**Re: 210 Bay Avenue – 210 Bay Avenue, LLC
Block 64, Lot 25
Review of Site Plan Plat Requirements (completeness)**

**Re: 210 Bay Avenue – 210 Bay Avenue, LLC
Block 64, Lots 24 & 25
Amended Review of Site Plan Plat Requirements (completeness)
CBD Zone**

**Re: 210 Bay Avenue – Hung, 210 Bay Avenue, LLC
Block 64, Lots 24 & 25
First Engineering Review
CBD Zone**

Dwg. No.
A2
2 of 2

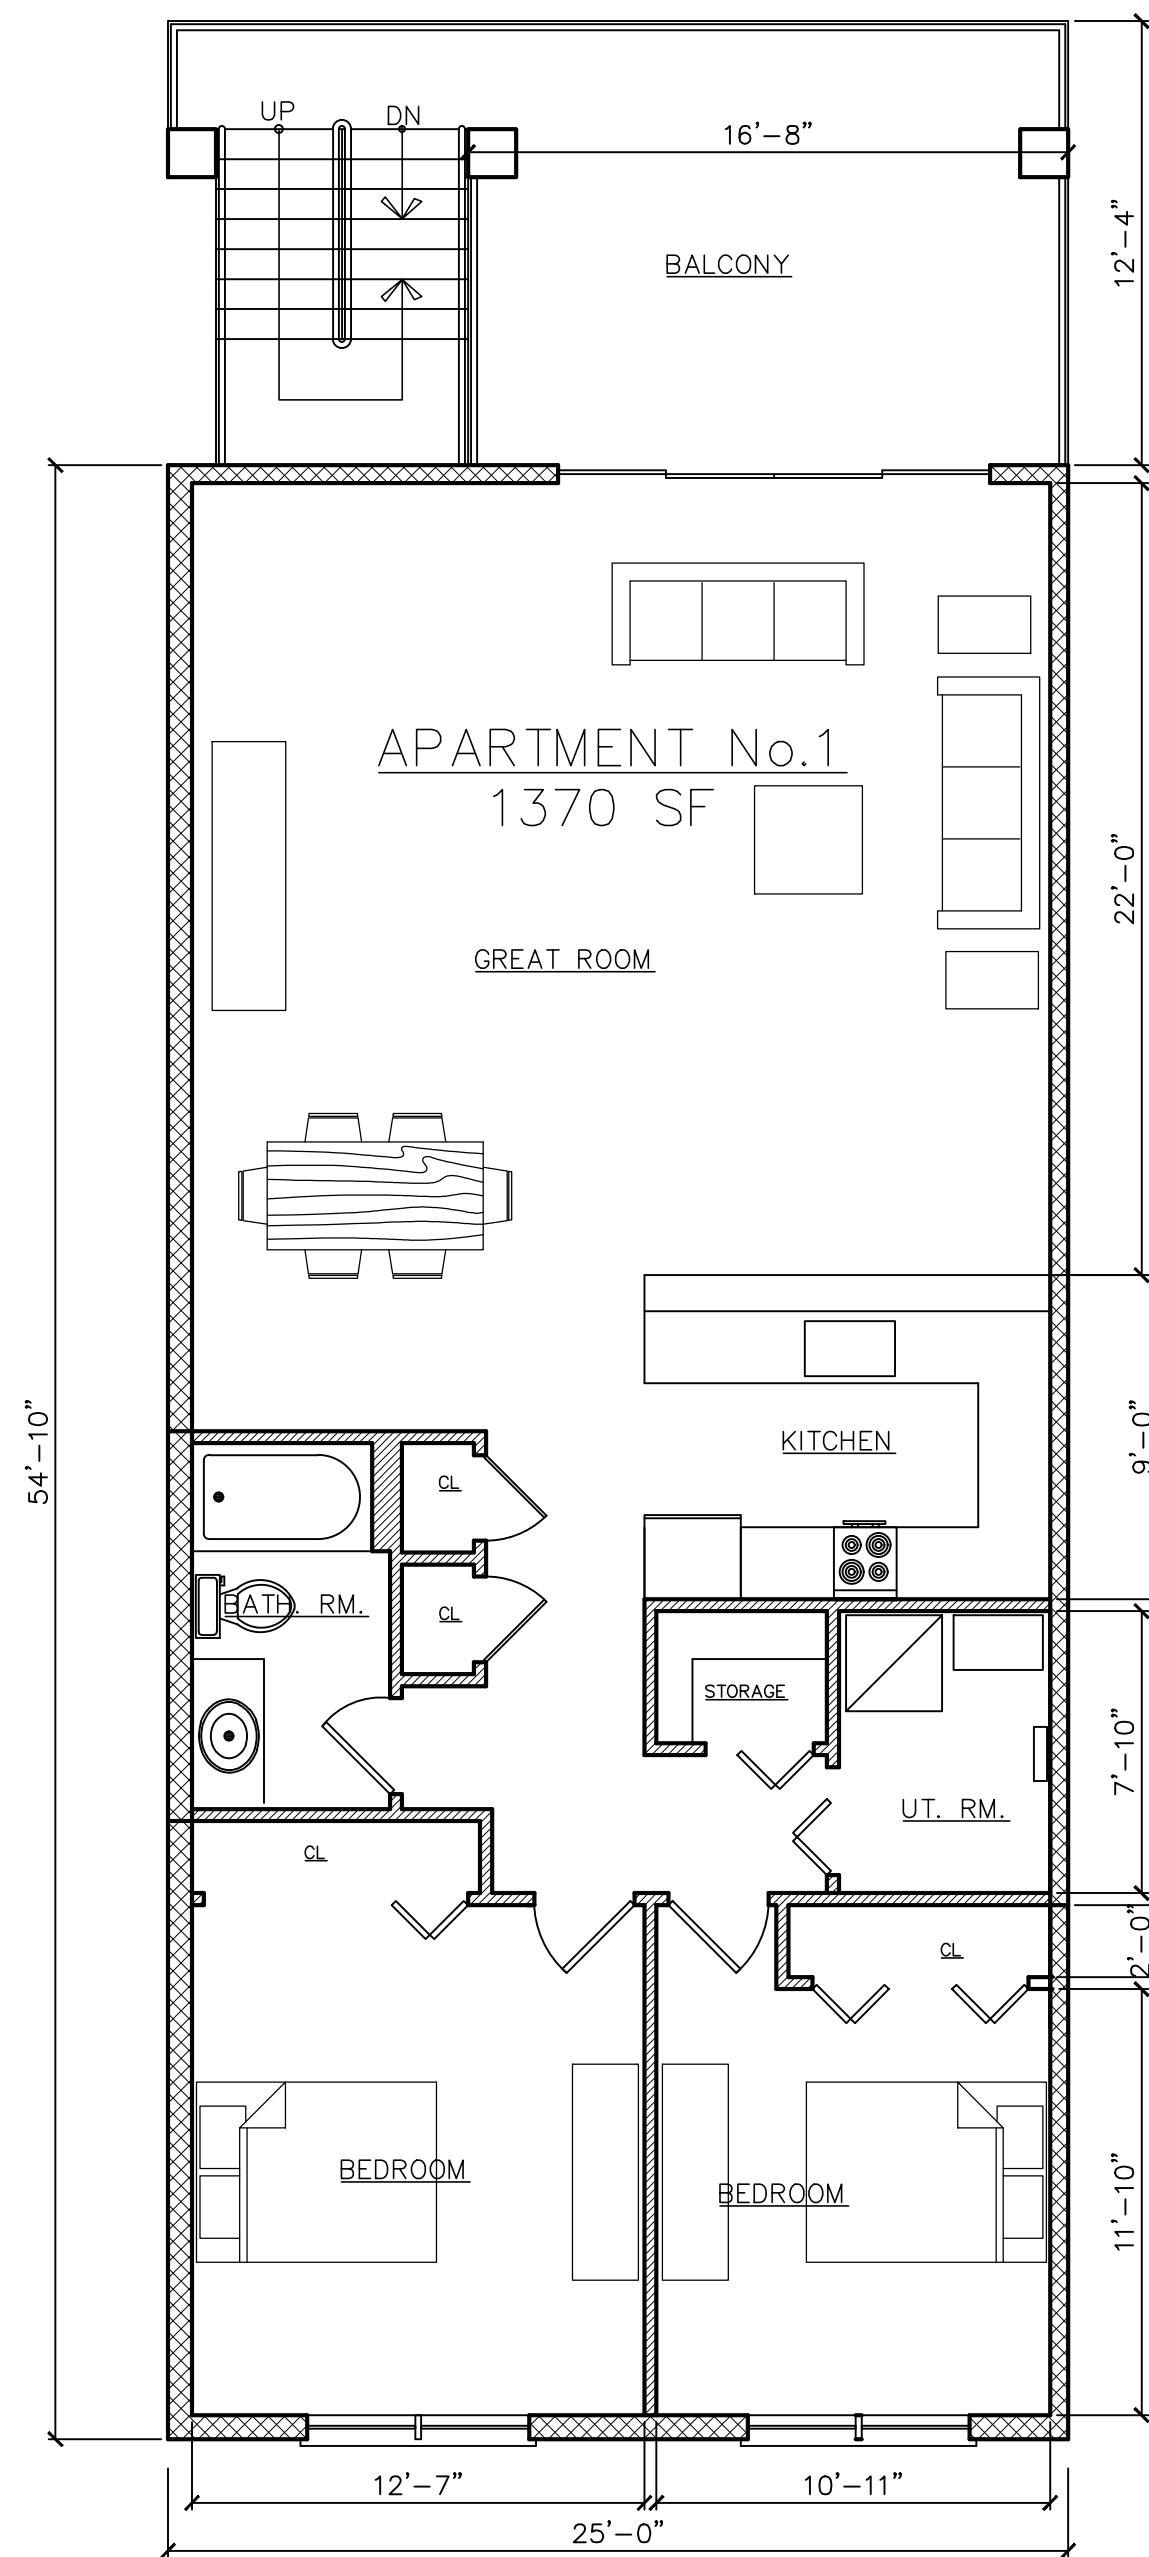
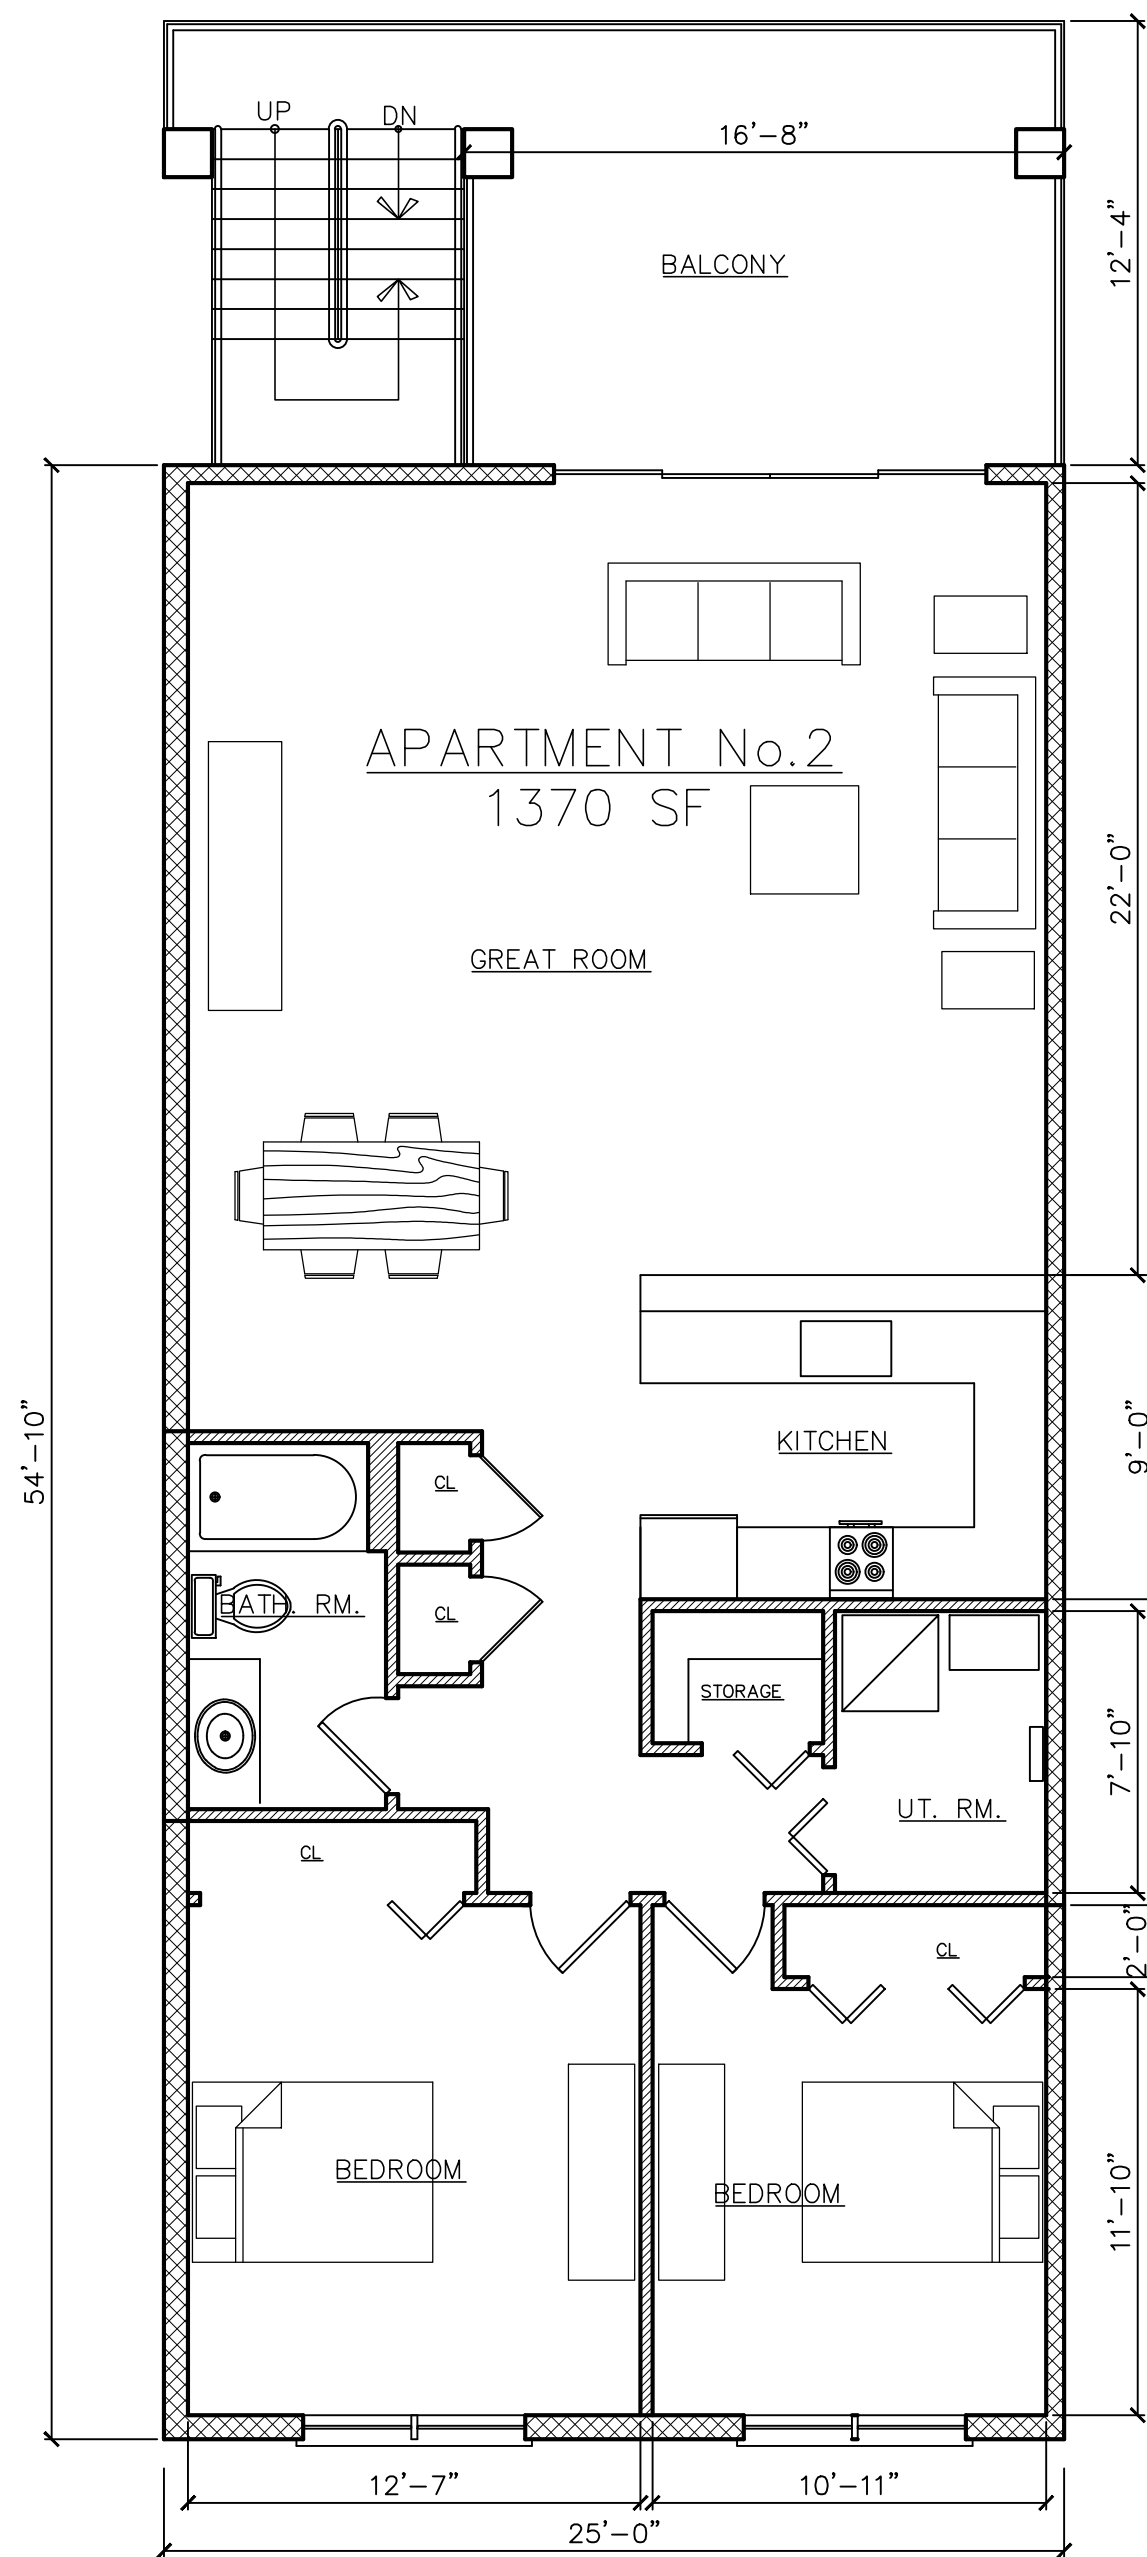
18. Preliminary architectural plans for the proposed buildings or structures indicating typical floor plans, elevations, heights and general design or architectural styling. **Partially provided. First floor plan not shown on plans.**

6. Preliminary architectural plans for the proposed buildings or structures indicating typical floor plans, elevations, heights and general design or architectural styling. **Partially provided.** *First floor plan not shown on plans. Applicant advised the Architect shall provide.*

9. An owner's consent signature block should be provided on the plans for the owners of both lot 24 and lot 25, consenting to the applicant's filing.
 10. An architectural floor plan shall be provided for the first floor. Clarification shall be provided that the intended first floor use is a restaurant. Testimony shall be provided regarding the method of construction for the easterly side line, as the new building is shown immediately abutting the adjacent building.
